**Addendum #2**  
to the  
**SPECIFICATIONS**  
and  
**CONTRACT DOCUMENTS, PLANS, AND SPECIFICATIONS**  
for  
**GOLDWATER LAKE PARK – DAY-USE EXPANSION PROJECT**

**Date of Addendum: August 8, 2013**

DRAWN	BWT	REVISED
DESIGN	BWT	
CHECK	GRK	
DATE	7/9/13	
JOB	13-013	
SHEET NO.	C4 of 17

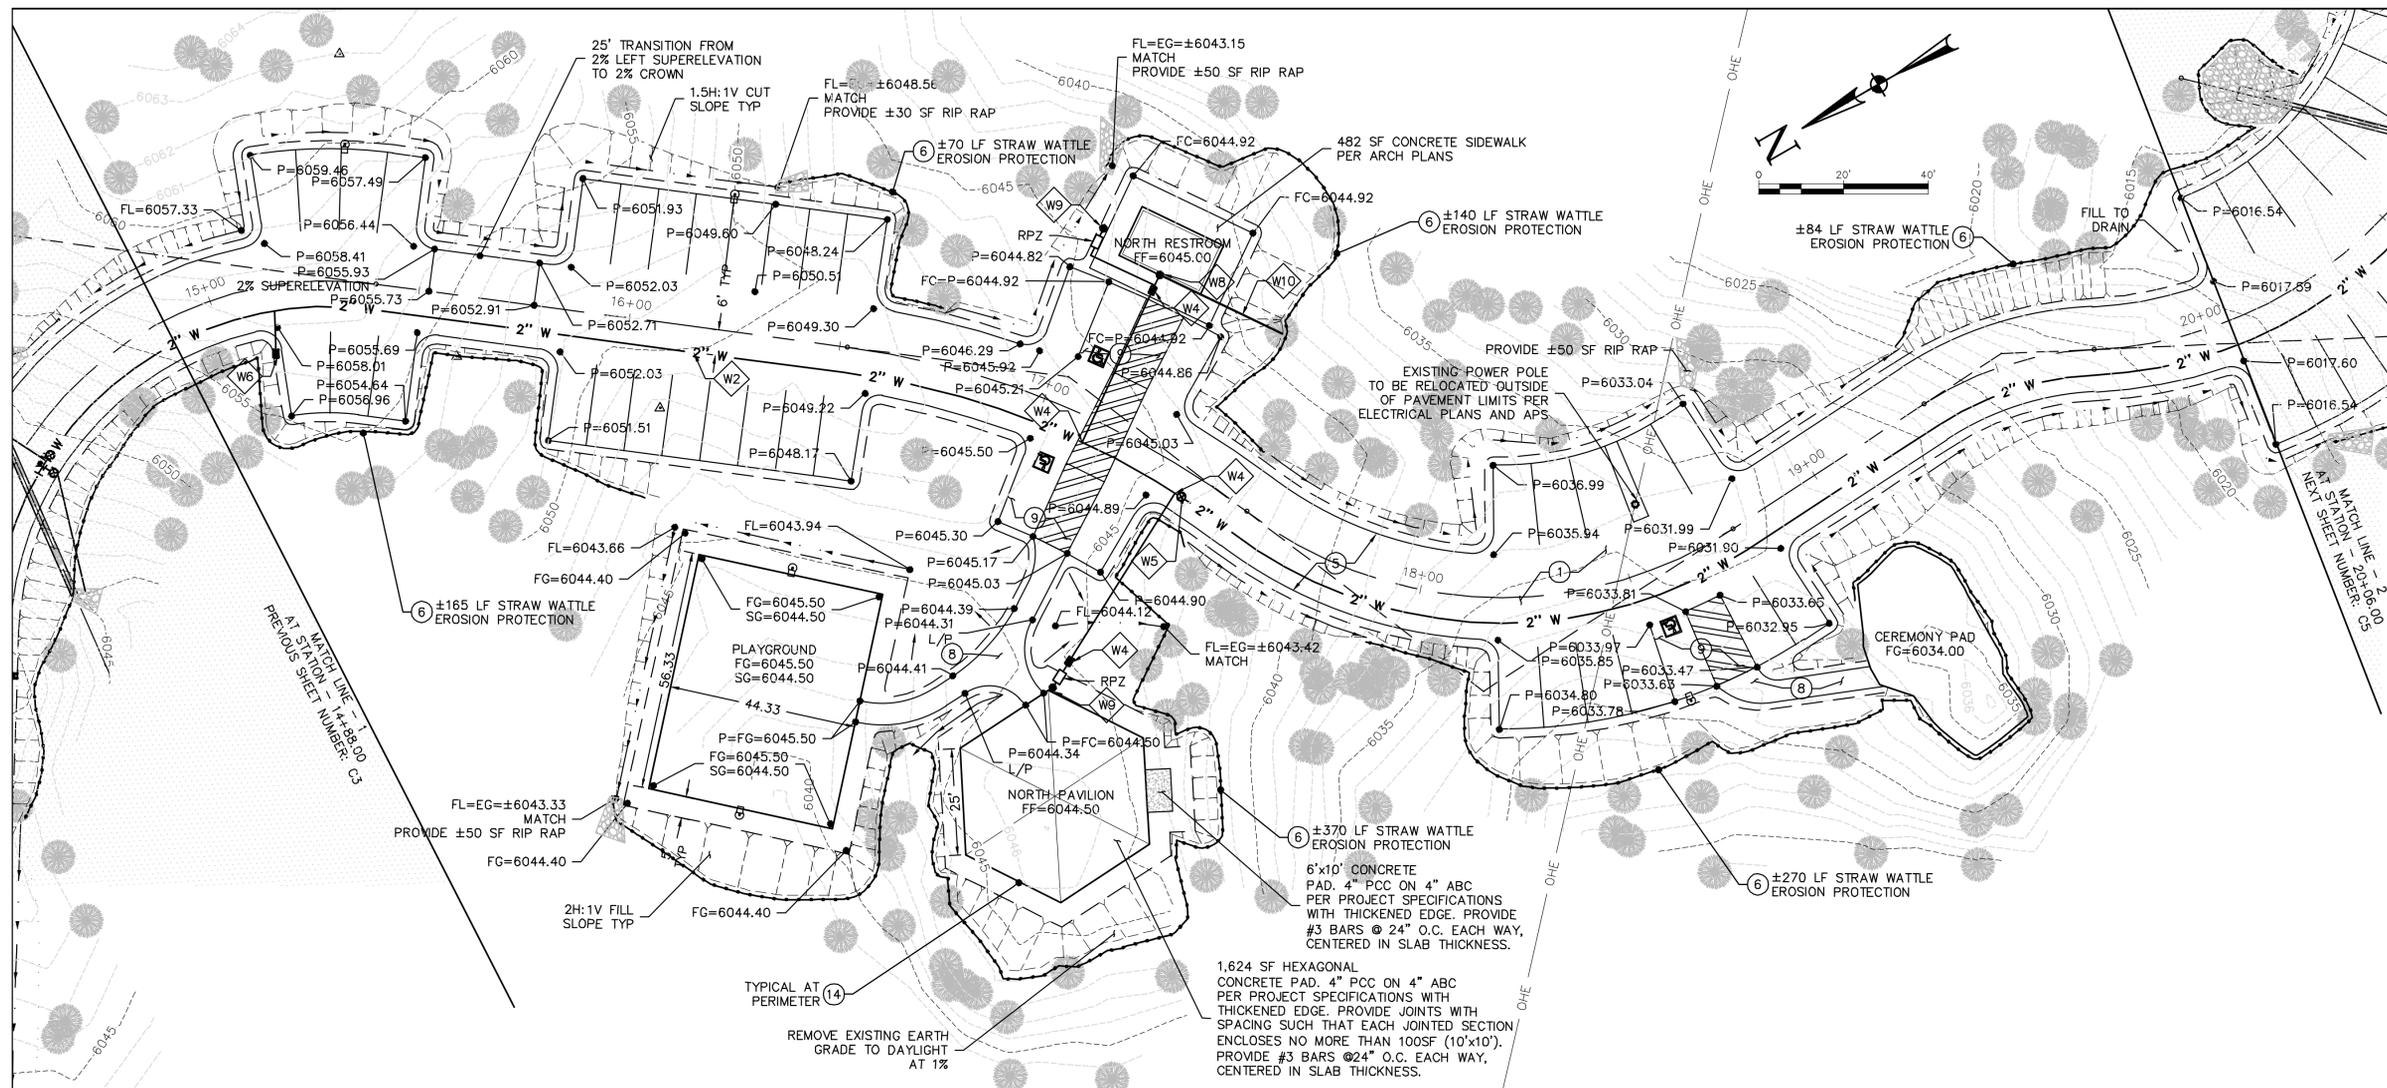
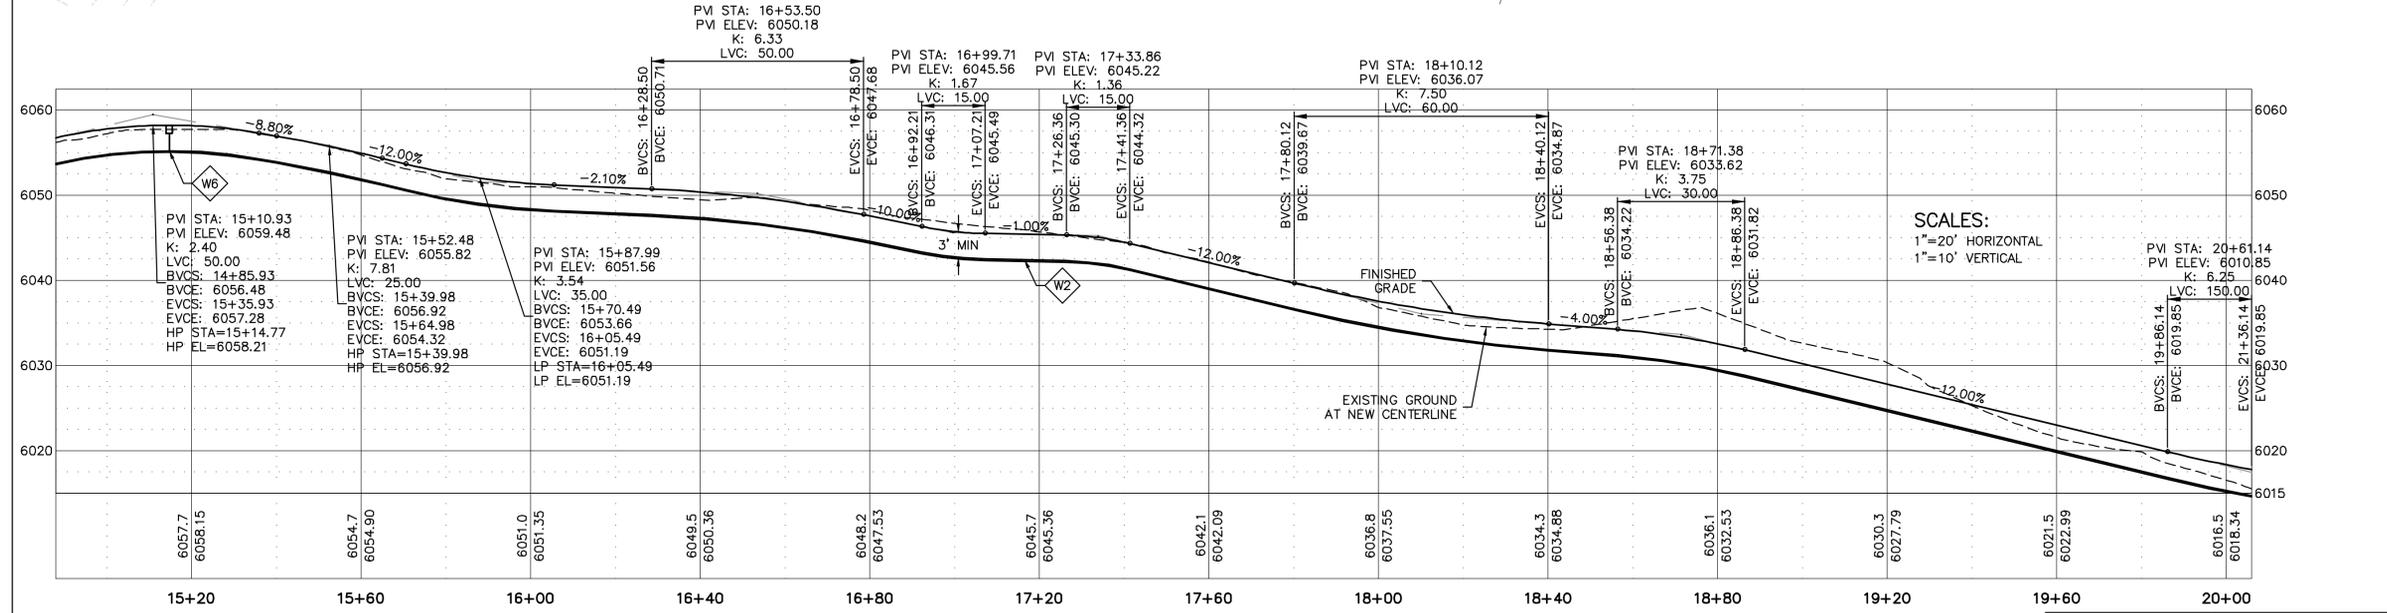
- 1. Revised Sheet C4** - Sheet C4 of the plan set has been revised to show a revised finished grade at the playground area and revised ADA walkway alignment and surfacing (2" AC on 2" ABC) from the ADA parking to the north pavilion and playground.

<b>GOLDWATER LAKE PARK DAY USE EXPANSION</b> PLAN AND PROFILE <b>KELLEY / WISE ENGINEERING, INC.</b>		DRAWN	BWT	REVISED
		DESIGN	BWT	
148 GROVE AVENUE PRESCOTT, ARIZONA 86301 (928) 771-1730 FAX 778-2220		CHECK	GRK	
		DATE	7/9/13	
		JOB	13-013	
SHEET NO. C5 of 17				8/6/13 AUDITORIUM #2

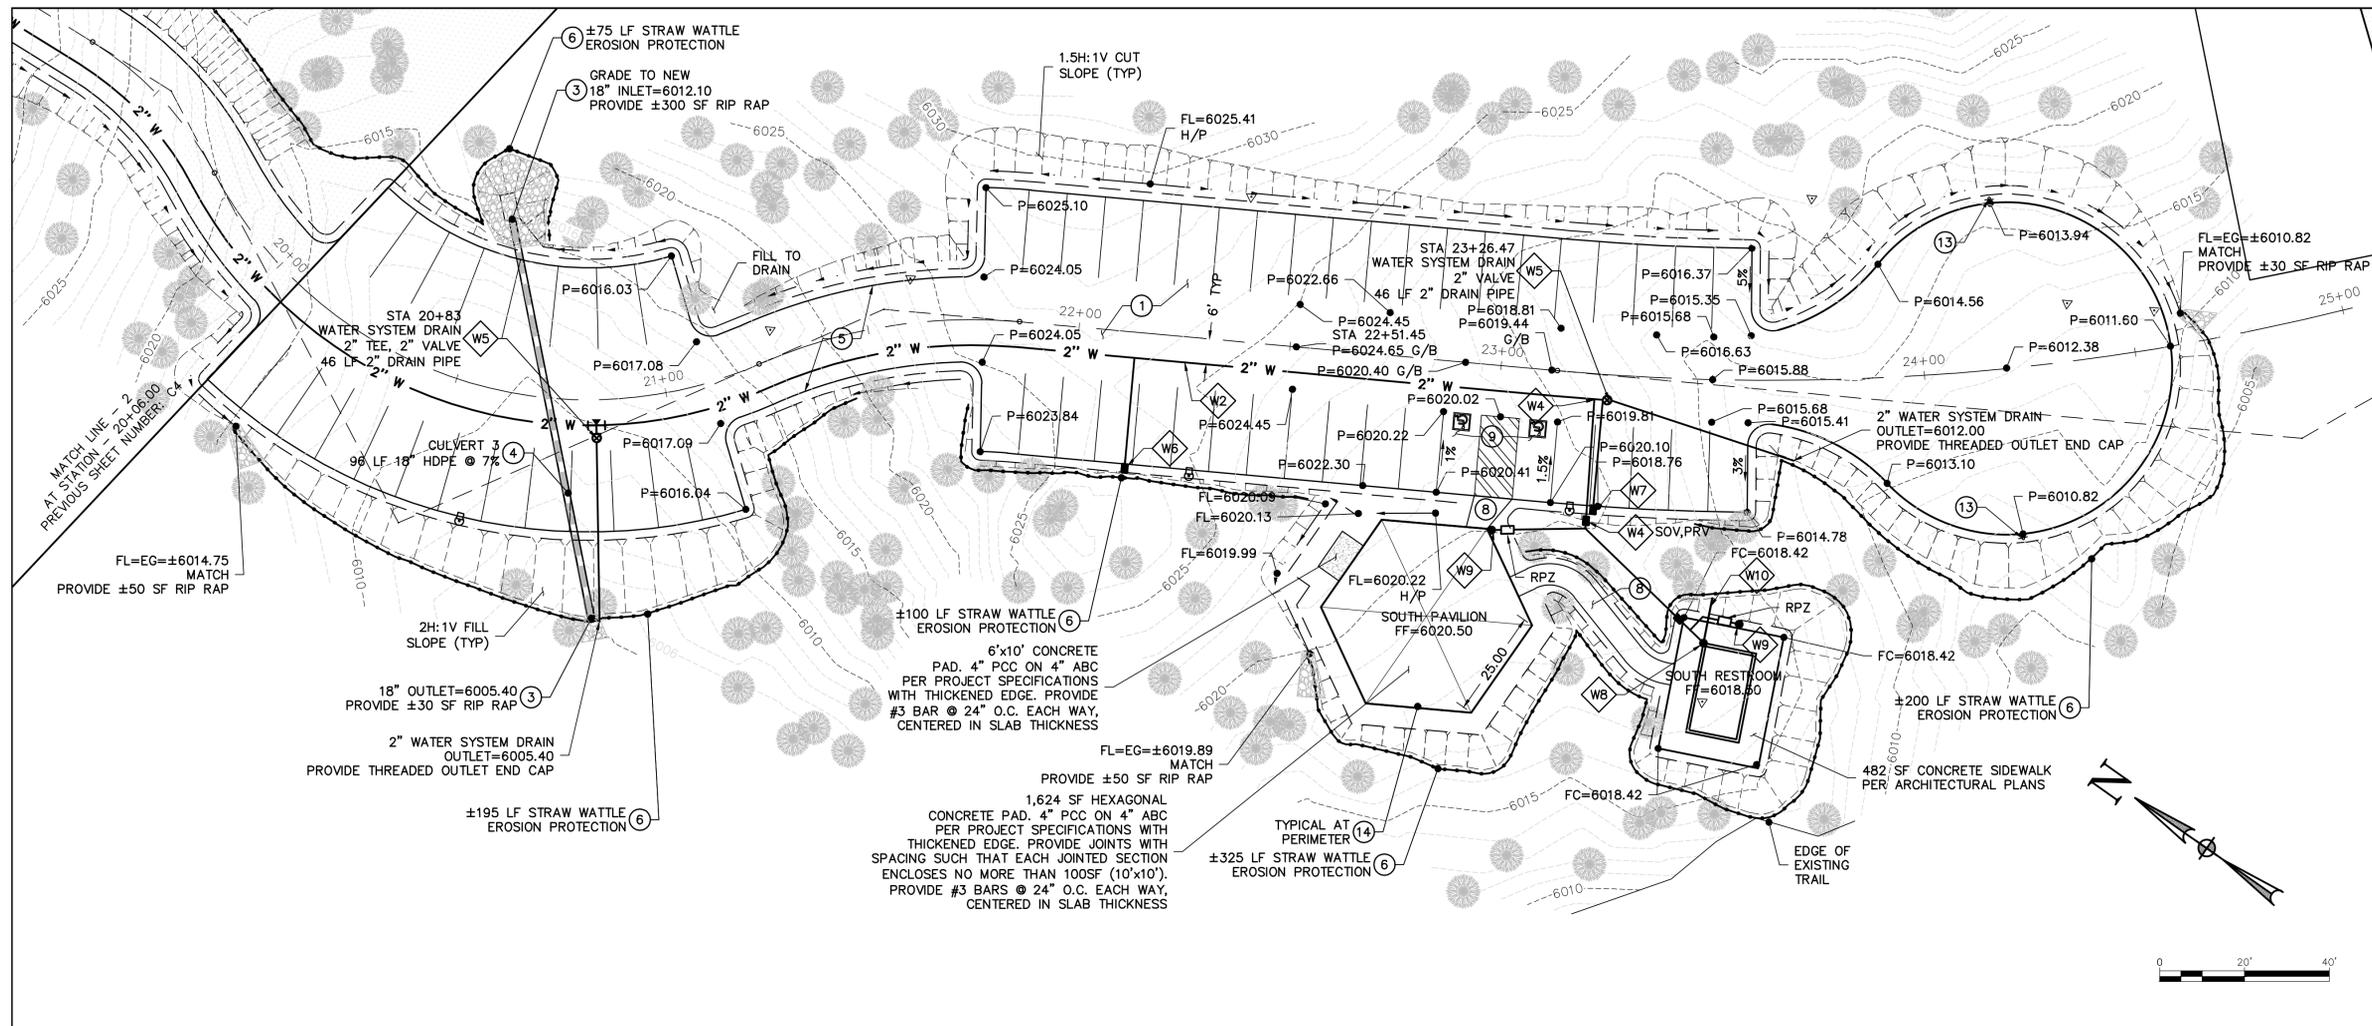
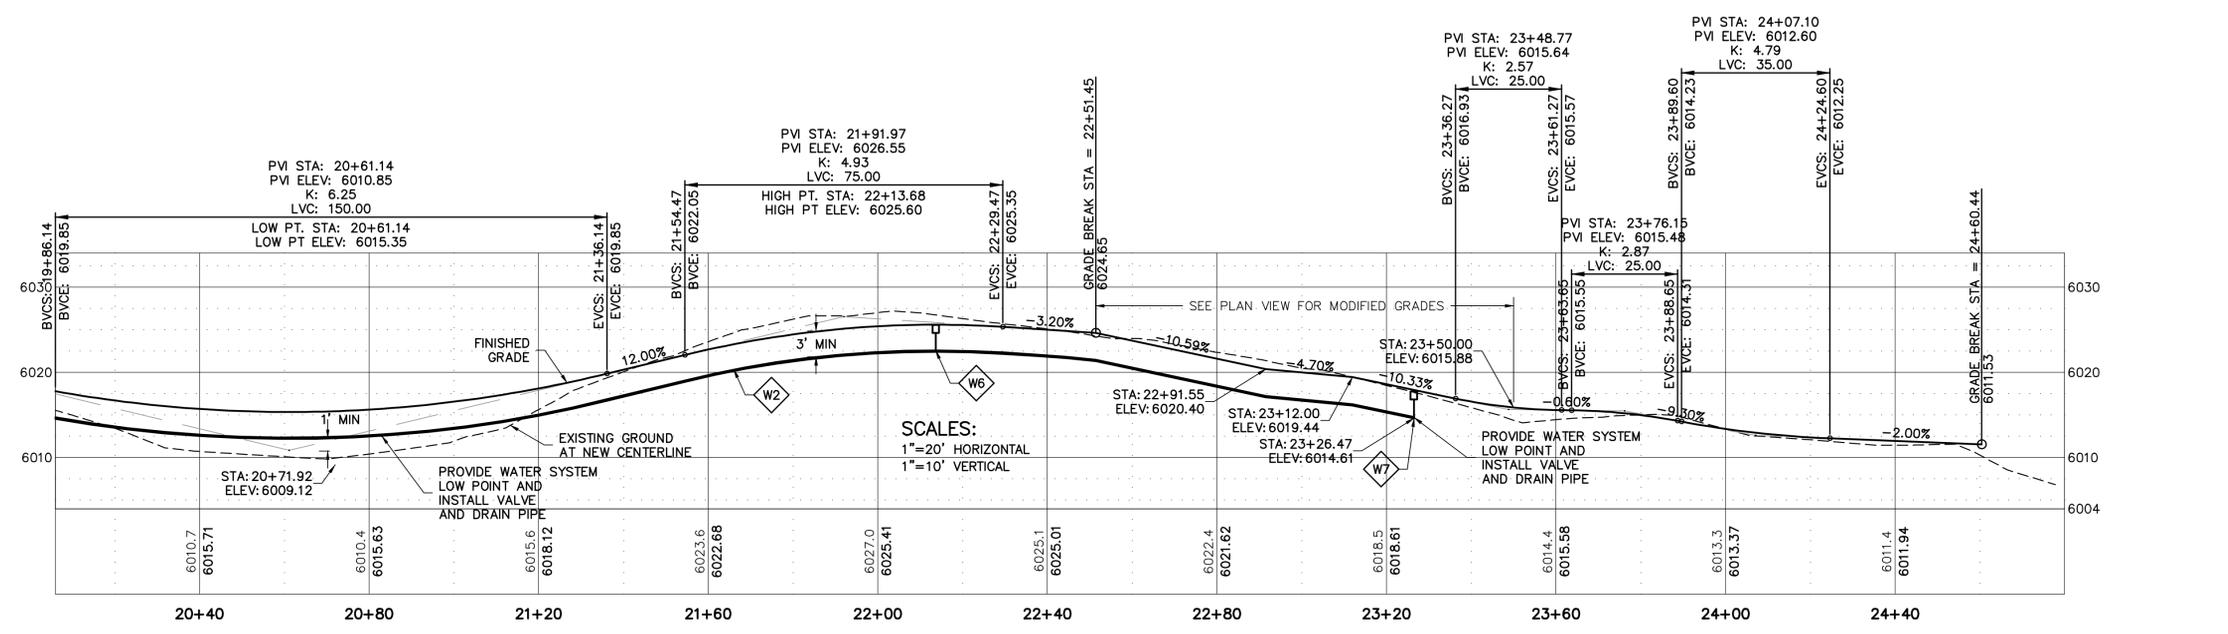
- 2. Revised Sheet C5** - Sheet C5 was revised to clarify grading adjacent to the ADA parking area near the south pavilion and to revise the ADA walkway surfacing (2" AC on 2" ABC) as well as clarification about the end station for the water main.
